CLIENT:
NORTHWEST KIDNEY CENTERS

PROJECT NAME:
RAINIER BEACH CLINIC

8.0 | EDG RESPONSE

ITEM BY ITEM RESPONSE [8.3]

FIGURE 2.A [17.2]

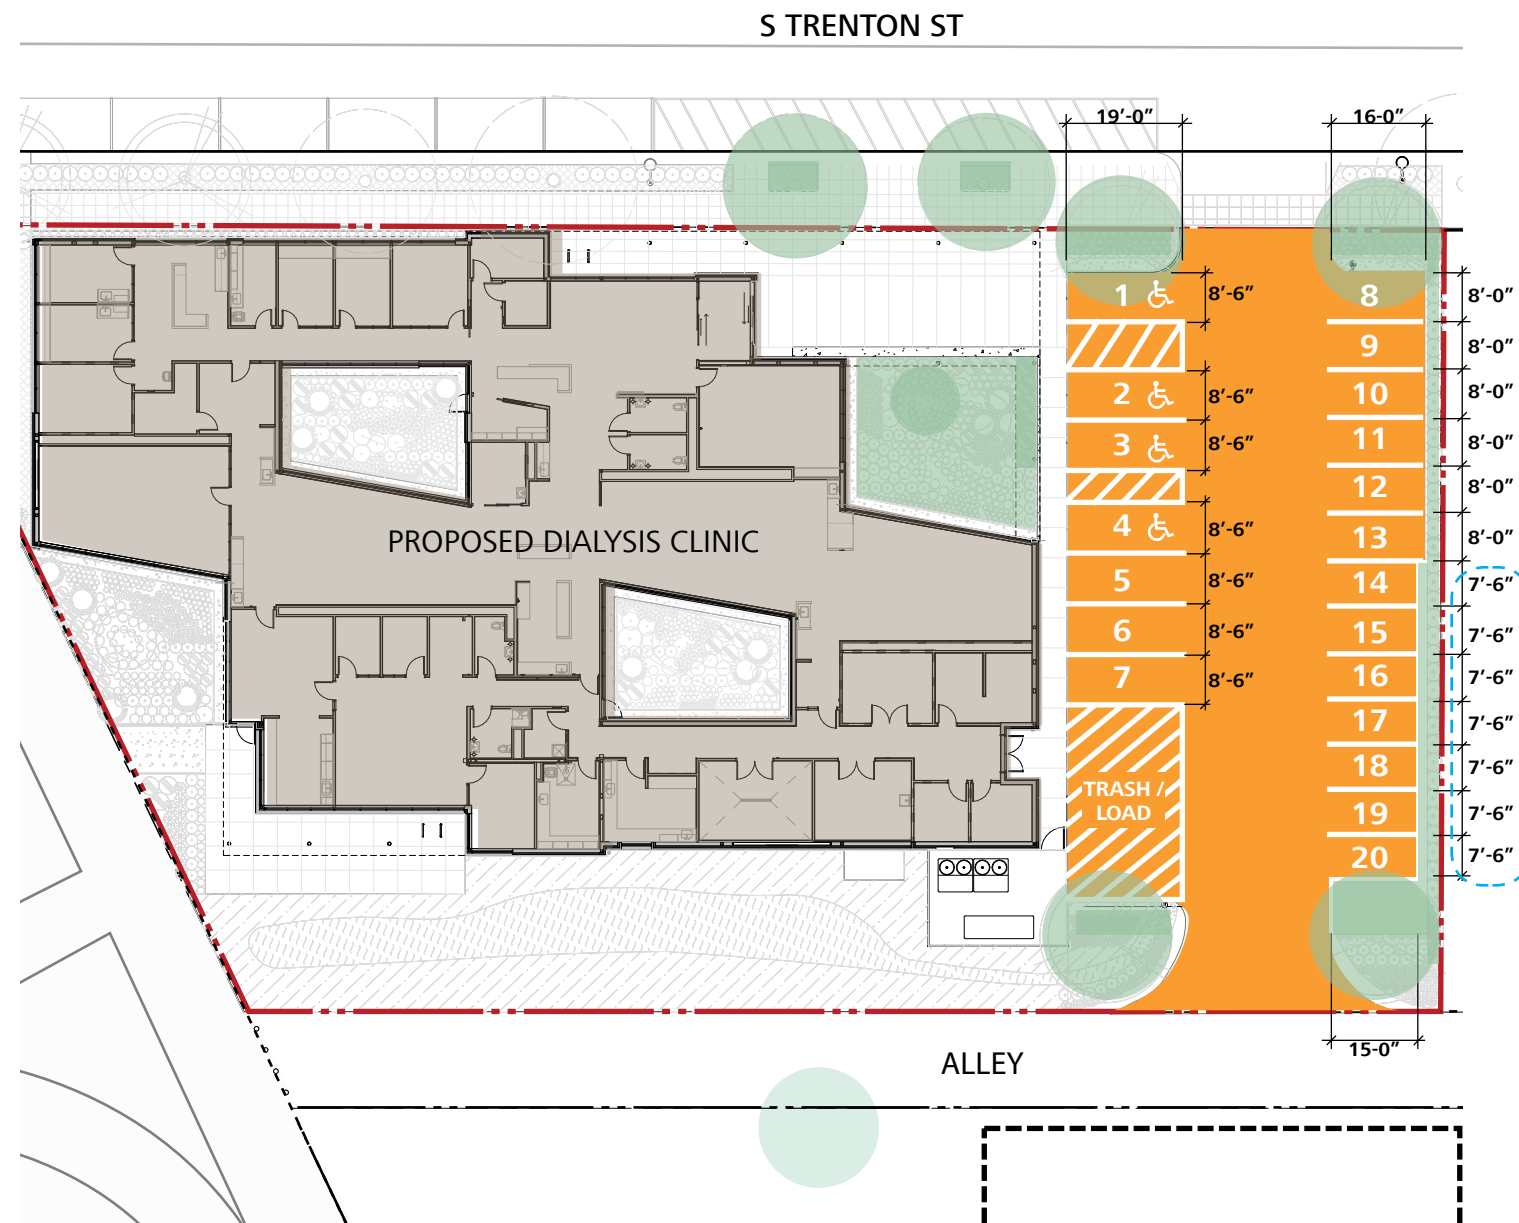
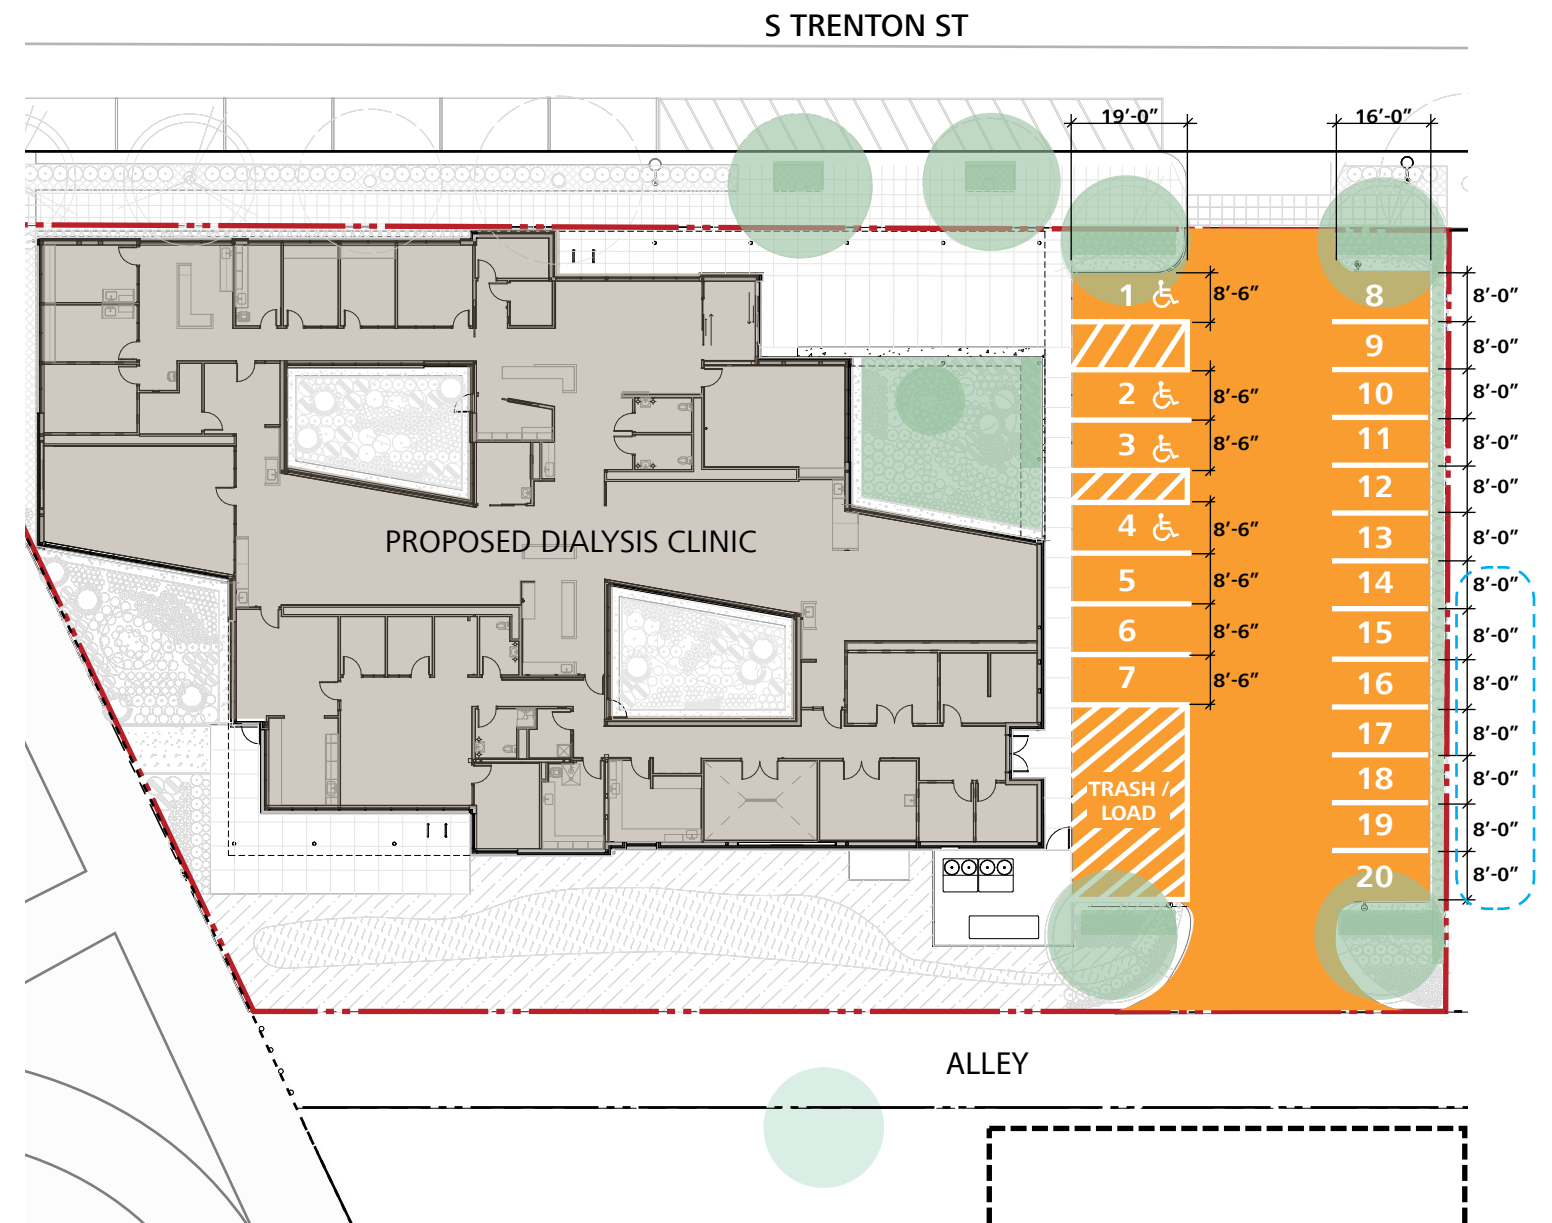
Per SMC 23.54.015, no parking is required for the site. However, 7 on-site, "large vehicle" and 13 "regular vehicle" parking spaces are desired by the Owner, Northwest Kidney Centers, to accommodate the patient, visitor, and employee parking needs typical for a dialysis clinic of this size. Due to the unique needs of the dialysis patient population, this quantity of large and regular parking spaces are desired to accommodate the typical range of vehicle sizes for patients and provide extra room for getting in and out of the vehicles.

Seattle Design Guidelines PL4 (Active Transportation) A.1 notes that "Serving all modes of travel: **provide safe and convenient access points for all modes of travel.**" The reduction in size of 7 standard parking spaces would restrict the total available patient parking for those with non-compact vehicles and would prove to be less safe and convenient for the patient and visitor population using the parking lot.

Additionally, the project has already provided landscaped screening in accordance with Seattle Design Guidelines DC1 (Project Uses and Activities) C.1, which encourages projects to "**reduce the visual impacts of parking lots, parking structures, entrances, and related signs and equipment as much as possible.**" Per (FIGURE 2.A), the impact of the parking lot on the site and the screening strategy is consistent for both the requested departure and the code compliant layout.
